Sicherheitsmitteilung SM 130101

Betrifft: ICON Gurtzeuge / Launch des ICON Reserve-Pilotchutes

Icon Reserve Pilot Chute Failed to Clear Side Flaps, Ser #IN-I5-12509, DOM Sep 2008

Regarding test-report for pilotchute hesitation on Icon I5 SN#12509

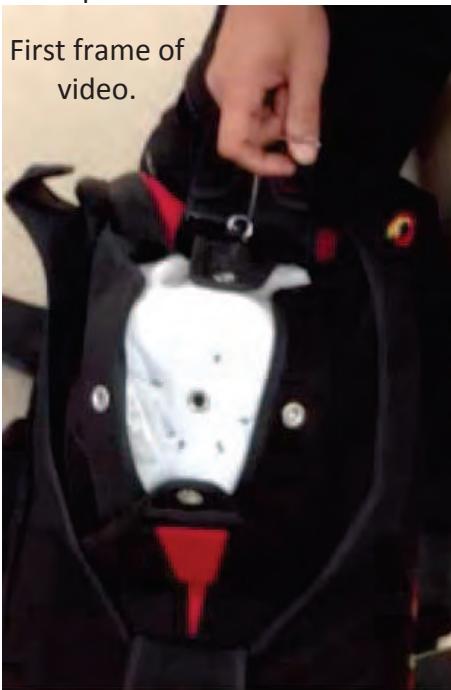
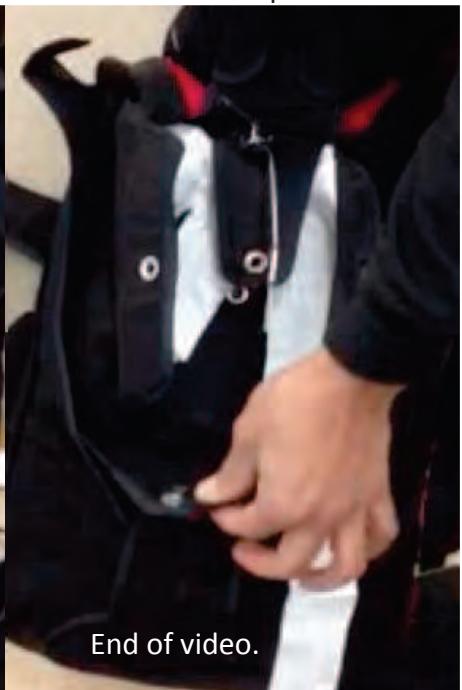
19 November 2012 it was reported that when the pin was pulled for routine repack, the reserve pilot chute failed to clear the side flaps and a video was provided as shown in the captures below.

It was noted from the provided video that the rig was not being worn and the pin was not pulled by its handle. The video shows that it was sitting on the ground and appears to have been pulled by the cable close to the pin, this would mean that this rigger's hand had to have contacted the #5 flap once the pin was clear of the loop interfering with its normal activation.

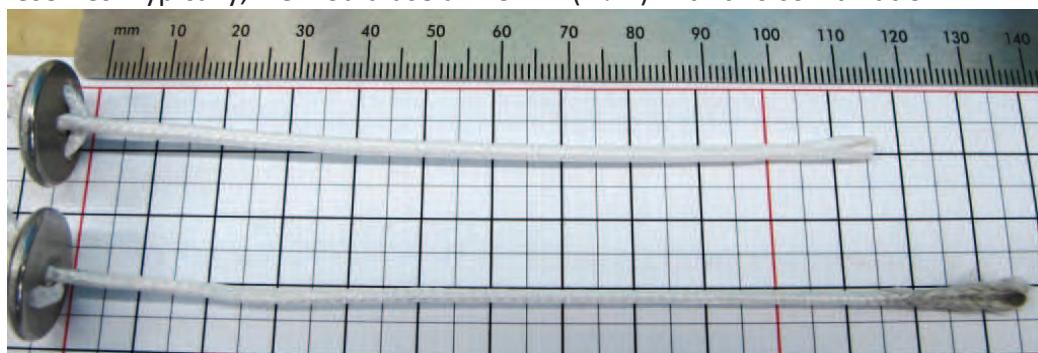
The rig arrived 29 November 2012 with the reserve closed as shown below and the first observation was that the loop was on the excessively long side and the reserve PC was not at full compression.

After opening, the loop measured to be 137mm (5 $\frac{3}{8}$ "), this is common length used here on tandem reserves. Typically, we would use a 115mm (4 $\frac{1}{2}$ ") with this combination.
